SUBJECT: R.E. GINNA NUCLEAR POWER PLANT - STAFF ASSESSMENT OF INFORMATION PROVIDED PURSUANT TO TITLE 10 OF THE *CODE OF FEDERAL REGULATIONS* PART 50, SECTION 50.54(f), SEISMIC HAZARD REEVALUATIONS FOR RECOMMENDATION 2.1 OF THE NEAR-TERM TASK FORCE REVIEW OF INSIGHTS FROM THE FUKUSHIMA DAI-ICHI ACCIDENT (TAC NO. MF3972)

STAFF ASSESSMENT BY THE OFFICE OF NUCLEAR REACTOR REGULATION

RELATED TO SEISMIC HAZARD AND SCREENING REPORT

R.E. GINNA NUCLEAR POWER PLANT

**Figure 3.3-1 Plot of Staff's and Licensee's Base Case Shear-Wave Velocity Profiles for the Ginna site**

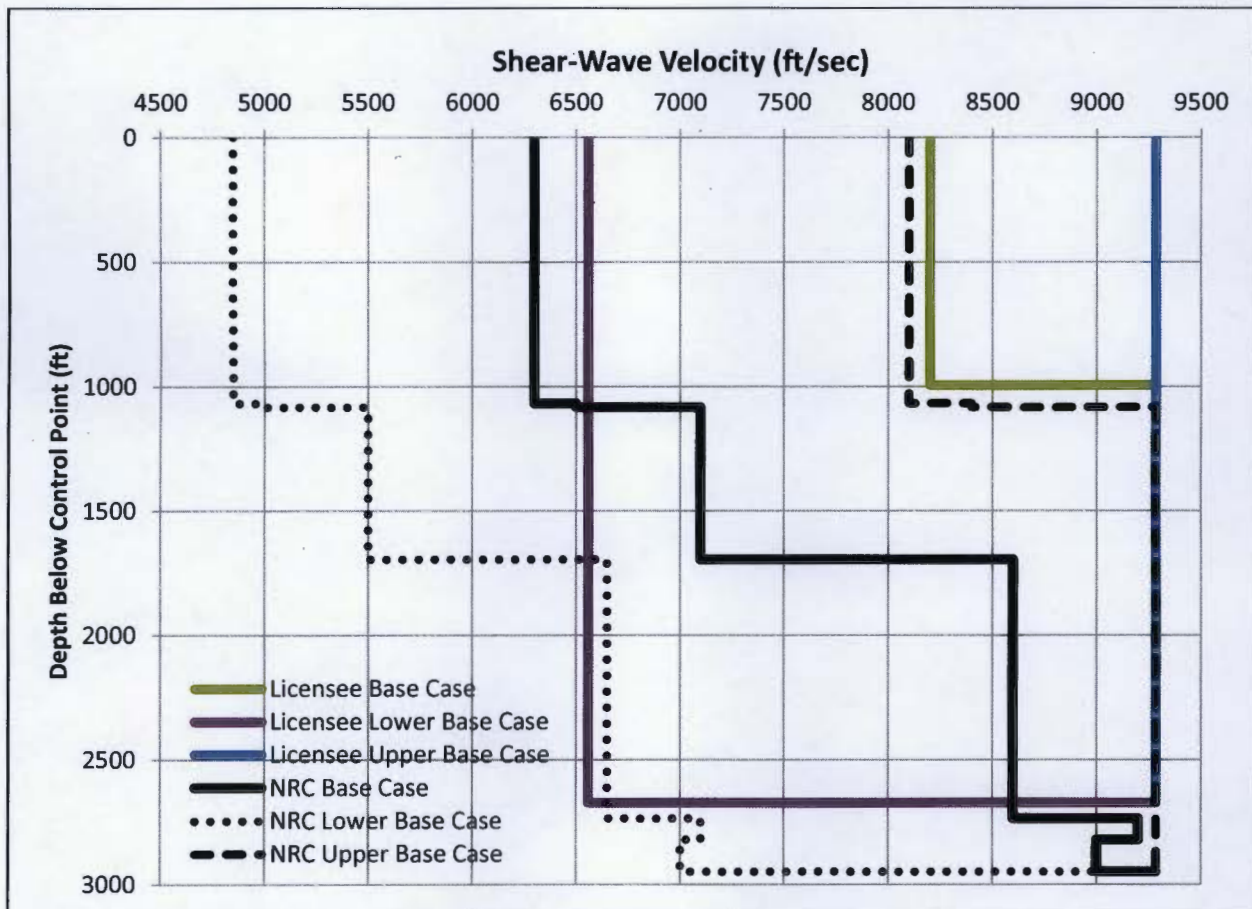
To characterize the subsurface geology, the licensee developed three site base case profiles. The middle, or best estimate, profile was developed using measured and assumed compressional wave velocities and assumed Poisson's ratios (a ratio of the compressional wave to shear wave velocity). The licensee developed upper and lower base case profiles using a natural log standard deviation of 0.2 and limited the upper base case velocity to 9,285 ft/s (2,800

m/s), the velocity of hard rock. Figure 3.3-1 of this assessment shows the licensee's three shear-wave velocity base case profiles.

**Figure 3.3-2 Plot Comparing the Staff's and the License's Median Amplification Functions and Uncertainties for the Ginna site**

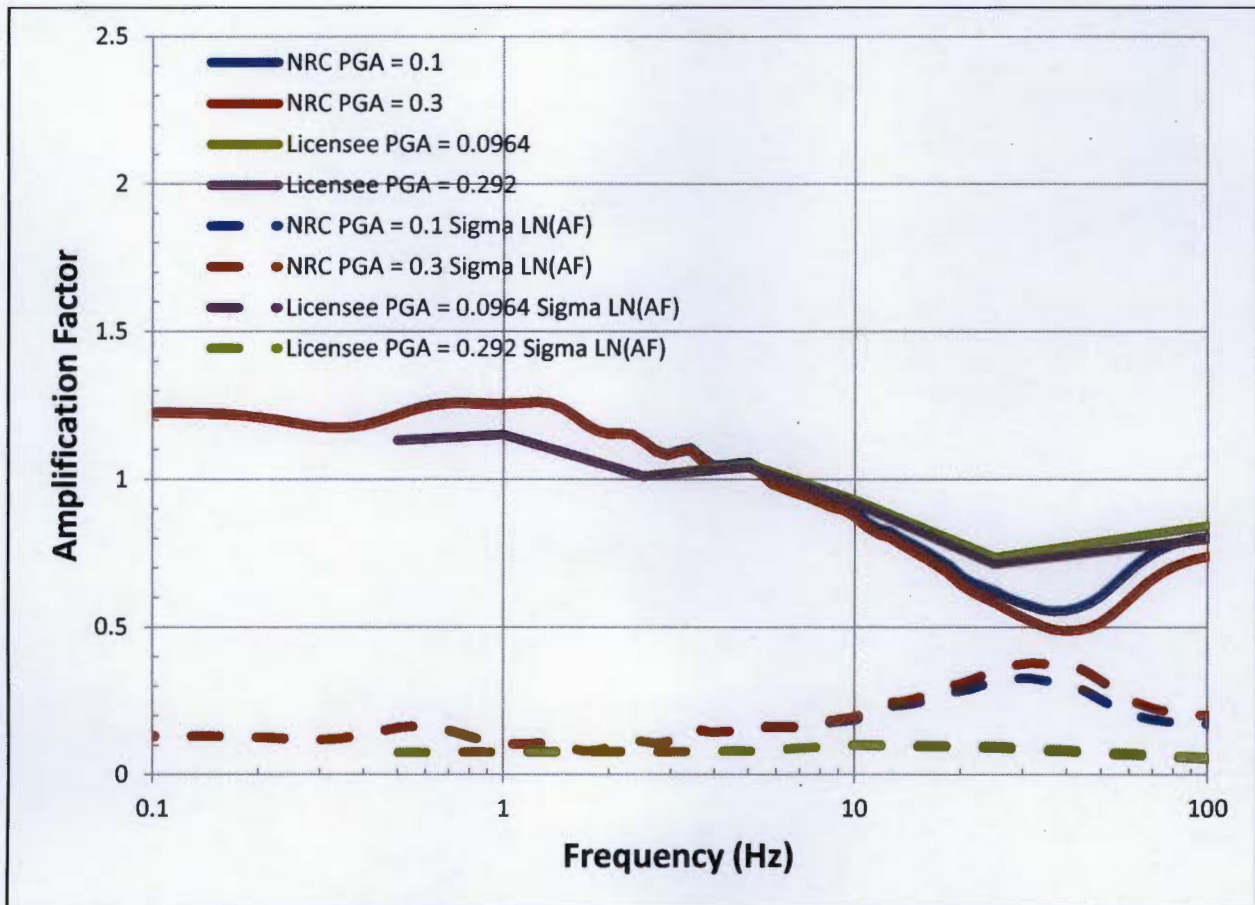
associated with estimating kappa for the Ginna site, for which limited subsurface data were collected. The staff gave the best-estimate kappa values for each profile a weight of 40 percent and the upper and lower kappa values a weight of 30 percent each in the site response analysis. Figure 3.3-2 of this assessment shows a comparison of the staff's and the licensee's median site amplification functions and uncertainties ( $\pm 1$  standard deviation) for two of the eleven input loading levels. The NRC staff's and licensee's amplification functions are generally similar in shape and amplitude. Amplification functions determined by the staff are slightly higher than those developed by the licensee for frequencies between 0.2 and 5 Hz. However, as shown in Figure 3.3-3 of this assessment, these differences in site response analysis do not have a large impact on the control point seismic hazard curves, or the resulting GMRS, as discussed below. Appendix B of the SPID provides guidance for performing site response analyses, including capturing the uncertainty for sites with less subsurface data; however, the guidance is neither prescriptive nor comprehensive. As such, various approaches in performing site response analyses, including the modeling of uncertainty, are acceptable for this application.

Figure 3.4-1 Comparison of the Staff's GMRS with Licensee's GMRS and the Ginna SSE

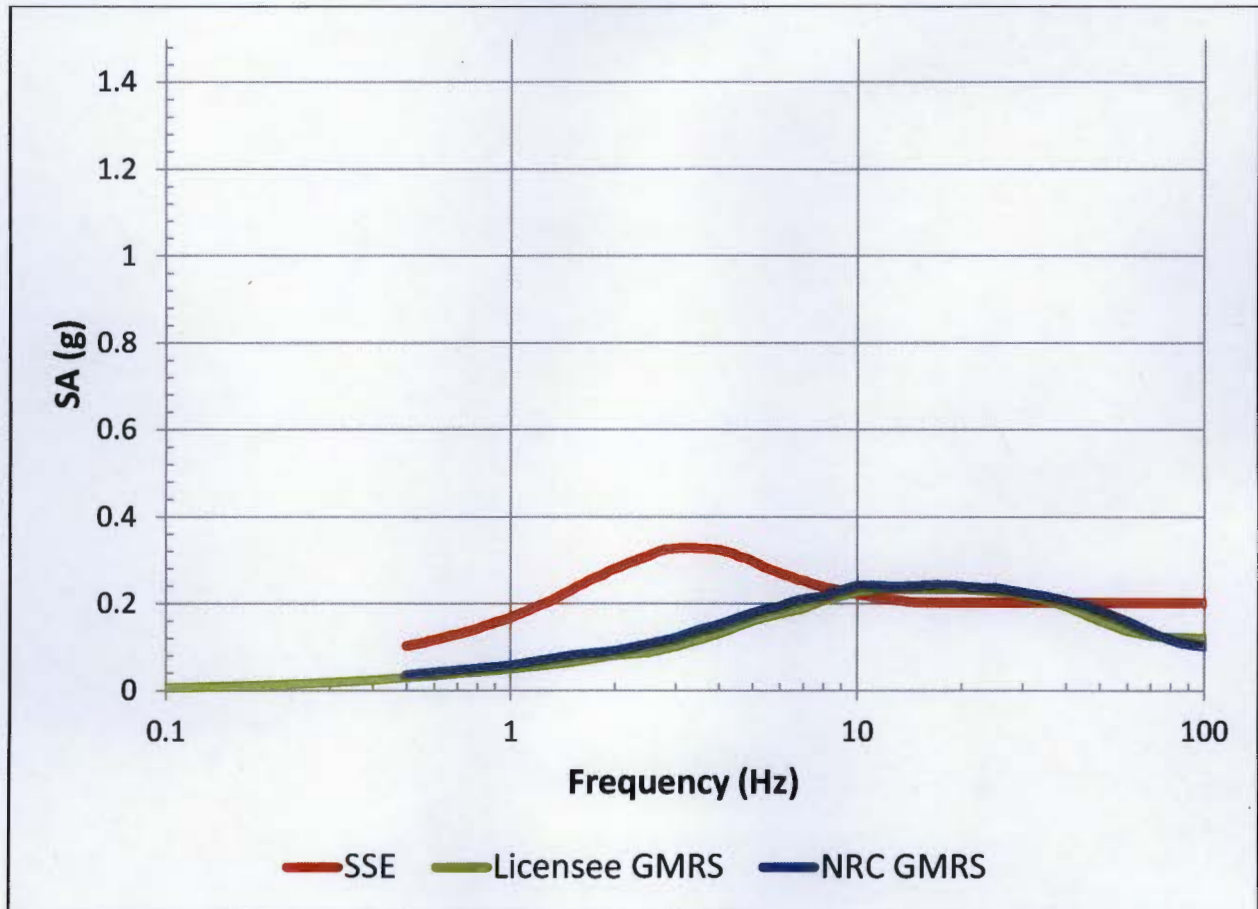
The NRC staff independently calculated  $10^{-4}$  and  $10^{-5}$  UHRS using the results of its confirmatory PSHA and site response calculations described in Sections 3.2 and 3.3 of this staff assessment, respectively. Figure 3.4-1 of this assessment shows a comparison of the GMRS determined by the licensee to that determined by the staff.

As shown in Figures 3.4-1 of this assessment, the NRC staff's GMRS is very similar to the licensee's in both amplitude and shape. The NRC staff confirms that the licensee used the present-day guidance and methodology outlined in RG 1.208 and the SPID to calculate the horizontal GMRS, as requested in the 50.54(f) letter. As such, the NRC staff concludes that the GMRS determined by the licensee adequately characterizes the reevaluated hazard for the Ginna site. Therefore, this GMRS is suitable for use in subsequent evaluations and conformations, as needed, for the response to the 50.54(f) letter. The NRC staff performed both a PSHA and site response confirmatory analysis and achieved results consistent with the licensee's horizontal GMRS.
